Project Name: Town of Hillsborough, Utilities Department
Adron F. Thompson Addition and Renovation
Project No.: 2231.01

ADDENDUM No. 3

Issued January 21, 2026

Site Electrical Plan

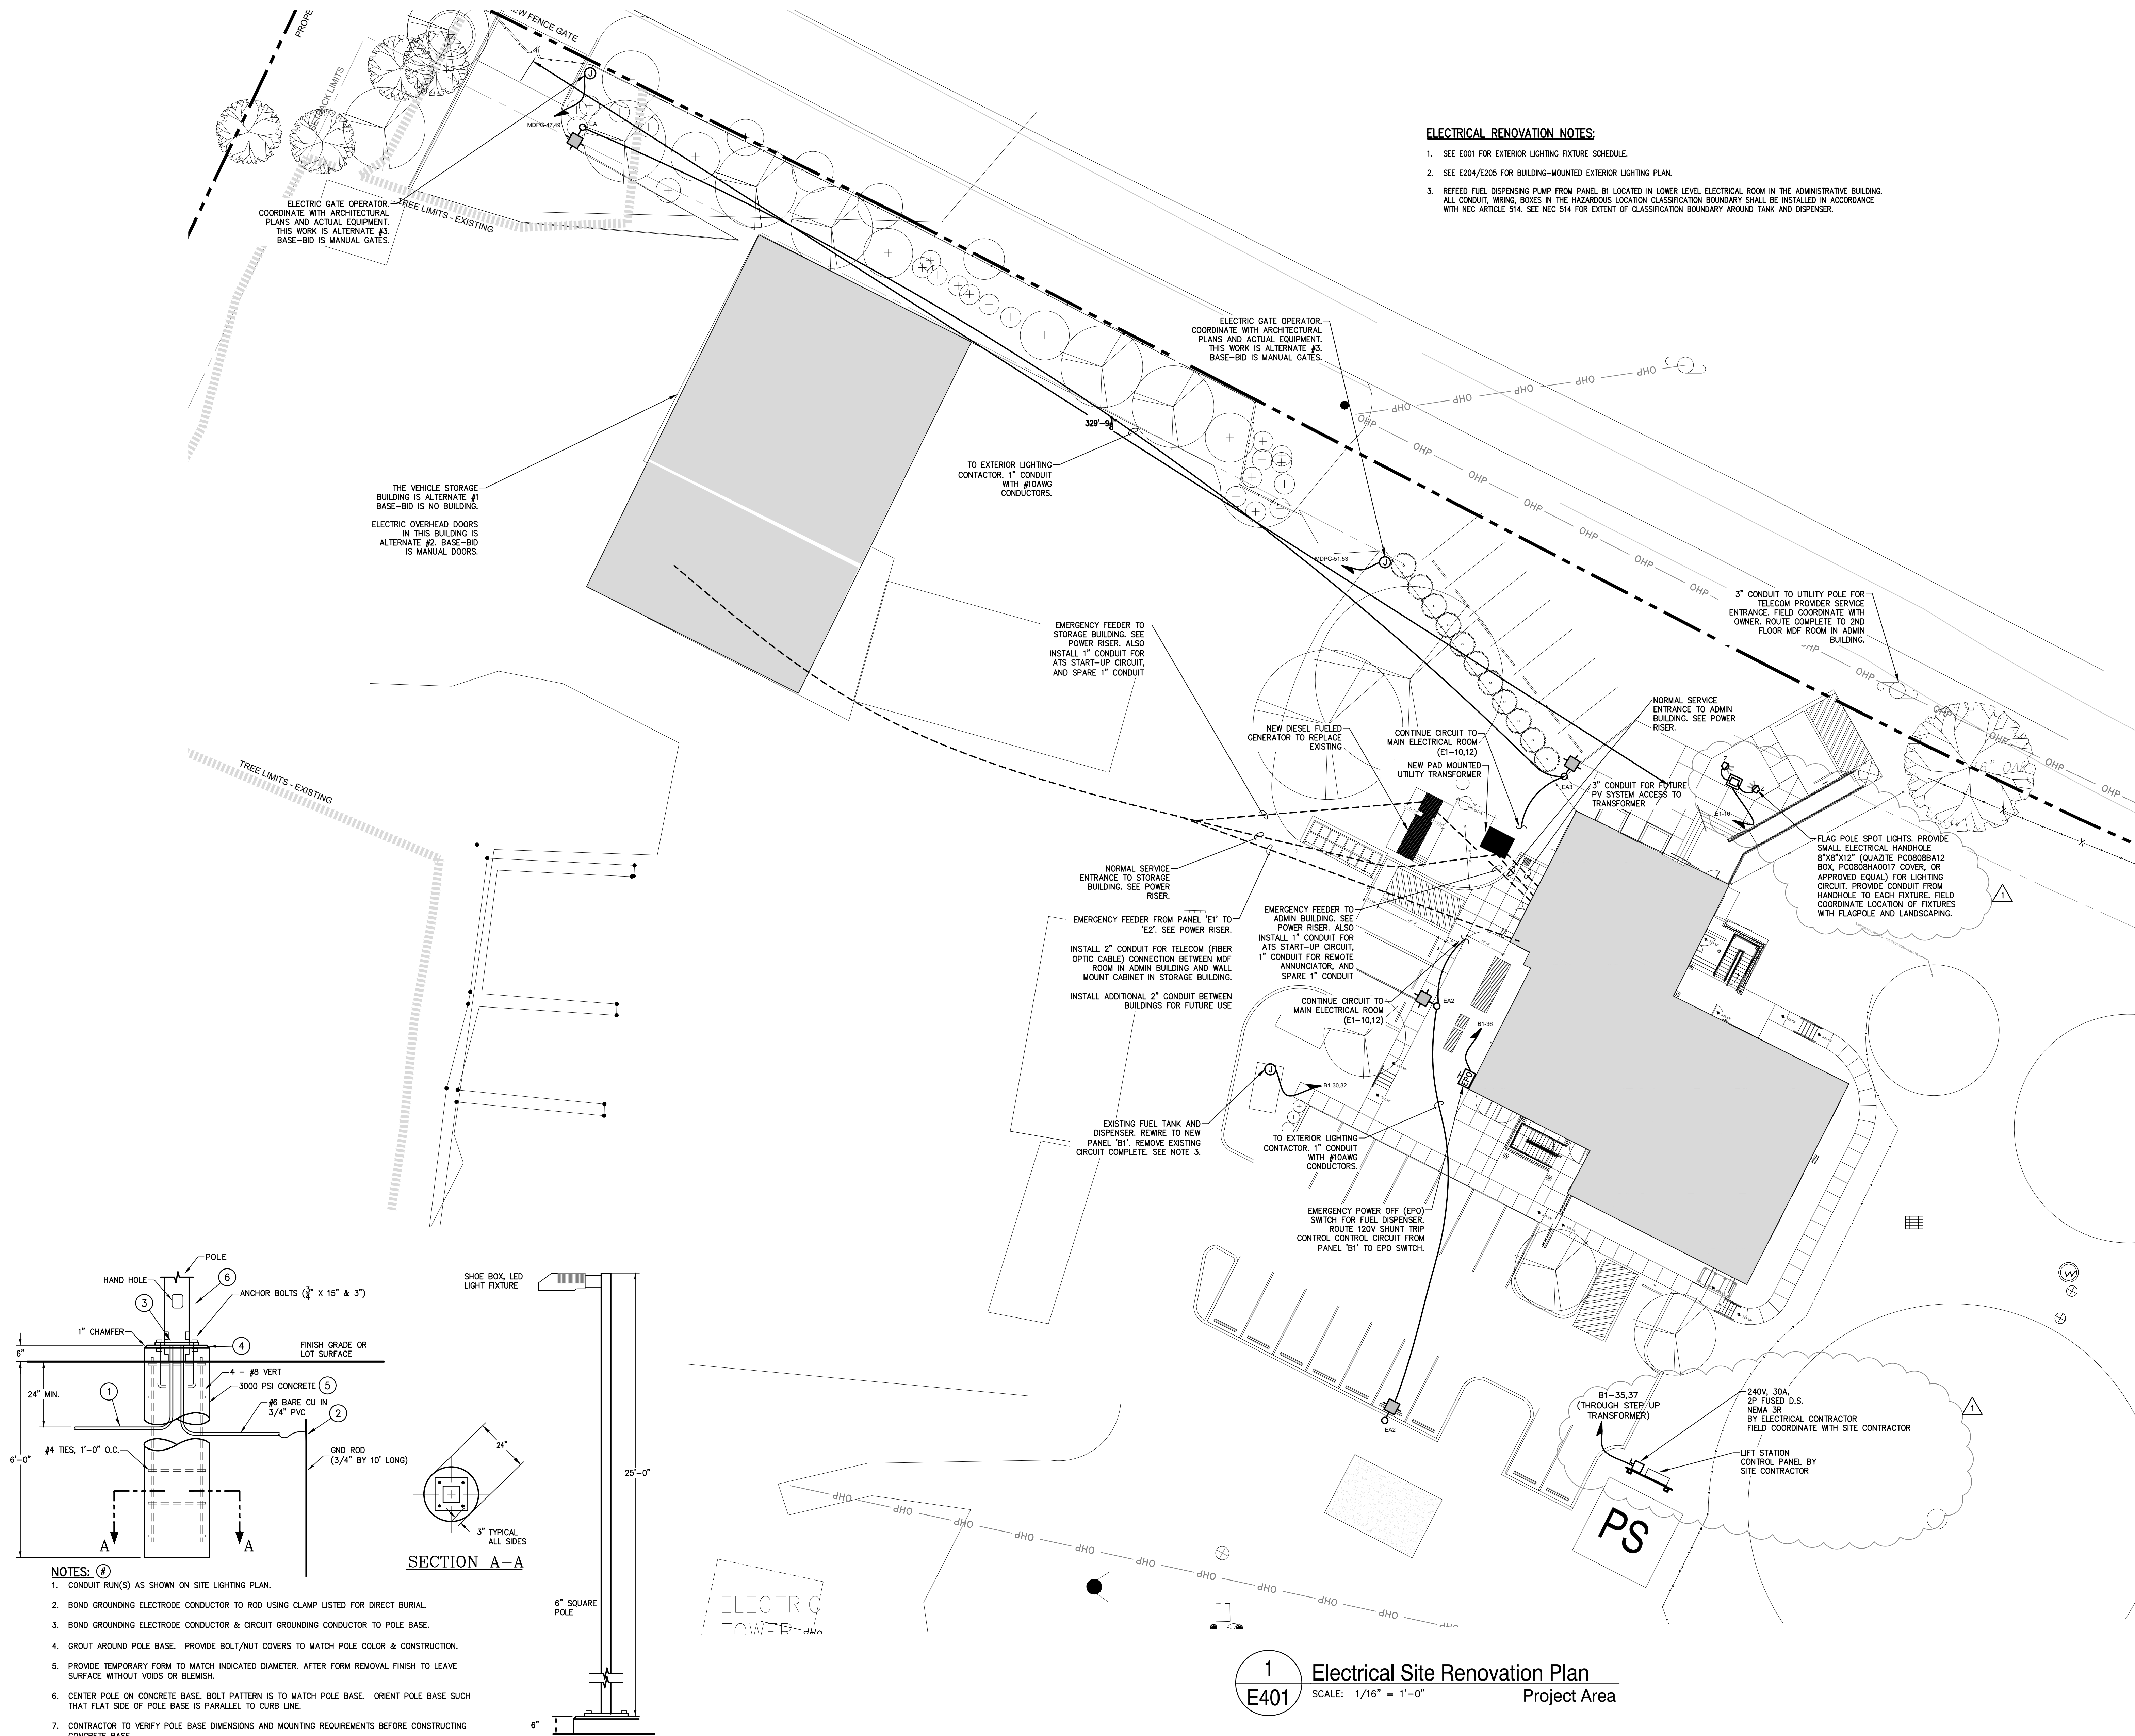
10. Replace sheet number **E401 SITE ELECTRICAL PLAN** with the attached sheet of the same number. Sheet revised to Add circuit for pump station; Added flag pole lights and circuit.
